Agenda Item # 10

SUB-002887-2024

West Mobile Masonic Temple Subdivision,
Resubdivision of Lot 1

WEST MOBILE MASONIC TEMPLE SUBDIVISION, RESUBDIVISION OF LOT 1

DETAIL SITE PLAN

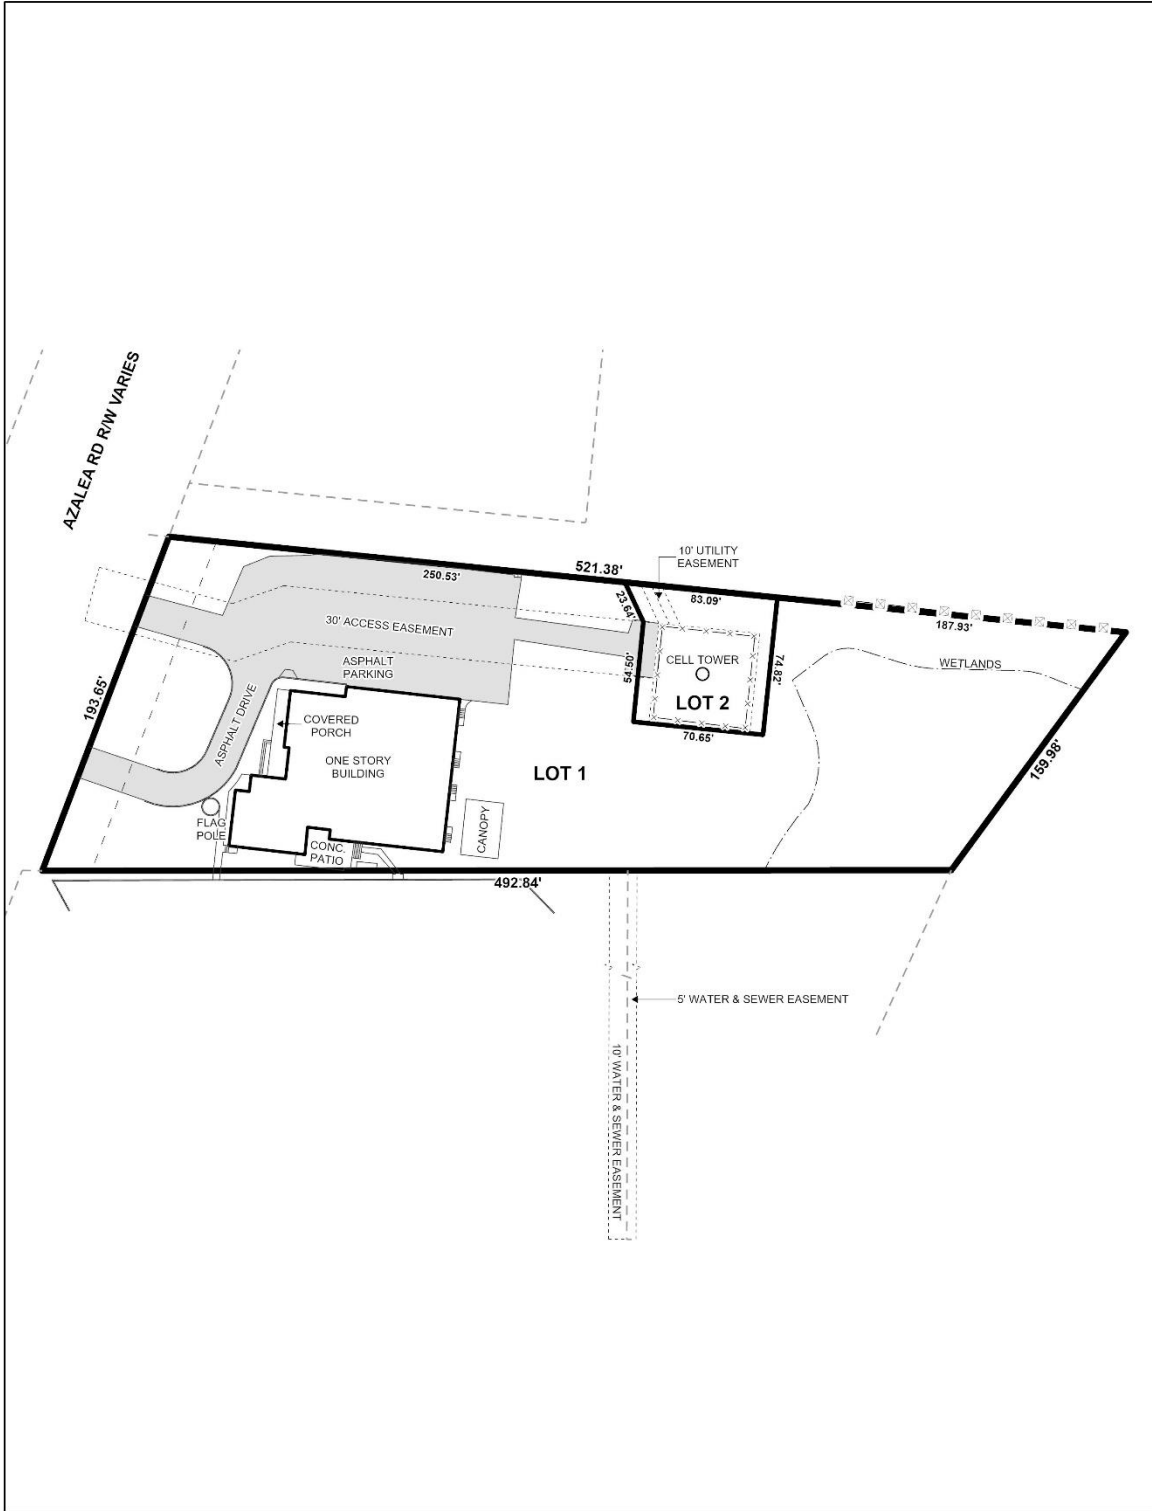
Proposed Lot 1 has frontage along Azalea Road, a minor arterial street requiring a 100-foot right-of-way. The plat depicts a varying right-of-way, but the 2019 recorded plat depicts sufficient right-of-way; therefore, no additional dedication should be required. If approved, the Final Plat should be revised to depict a minimum of 50-feet to the centerline of Azalea Road.

A ten-foot (10') utility easement is depicted on the preliminary plat. A note on the plat states no structure shall be constructed or placed within any easement without the permission of the easement holder. This note should be retained on the Final Plat, if approved.

Proposed Lot 2 does not abut a public street, as required by Section 6.C.4. of the Subdivision Regulations. A proposed 30-foot access easement is depicted on the preliminary plat, which would provide access to proposed Lot 2 from Azalea Road. Article 3, Section 64-3-2.A.1. of the Unified Development Code (UDC) states that developments may be accessed by a recorded dedicated easement or other recorded legal instrument. Moreover, in an effort to limit the number of access points along city streets, shared access is encouraged wherever possible by Article 3, Sections 64-3-4.B.1. and 64-3-4.C.1. of the UDC. The easement is a compliant width to accommodate two-way traffic.

Lot 1 exceeds the minimum size requirement for lots served by public water and sanitary sewer in a B-2 Suburban district, but Lot 2 does not. Proposed Lot 2 is 5,421.63 square feet, or 1,778.37 square feet less than the 7,200 square foot minimum for a B-2 Suburban district as stated in Section 6.C.2(a)(1) of the Subdivision Regulations. Lot 2 is proposed to accommodate the existing cell tower, which commonly have smaller than average lots and lease parcels associated. Lot sizes are provided in square feet and acres in a table on the preliminary plat. This information should be retained on the Final Plat, if approved.

A front yard setback is illustrated on proposed Lot 1, but not labeled, and no front yard setback illustrated on proposed Lot 2, as required by Section 6.C.8. of the Subdivision Regulations for lots in a B-2 Suburban district. As the proposed Lot 2 does not have a street frontage, a waiver of Section 6.C.8. of the Subdivision Regulations may be appropriate. If approved, revision of the plat to illustrate and label the 25-foot front yard setback for Lot 1 should be required.

1. Revision of the plat to depict a minimum of 50-feet from the front property line to the centerline of Azalea Road;
2. Retention of the lot sizes in both square feet and acre on the Final Plat, or provision of a table on the Final Plat with the same information;

3. Revision of the plat to illustrate and label the 25-foot minimum front yard setback for both lots;
4. Retention of all easements depicted on the preliminary plat;

5. Retention of a note on the Final Plat stating no structure shall be constructed or placed within any easement without the permission of the easement holder;
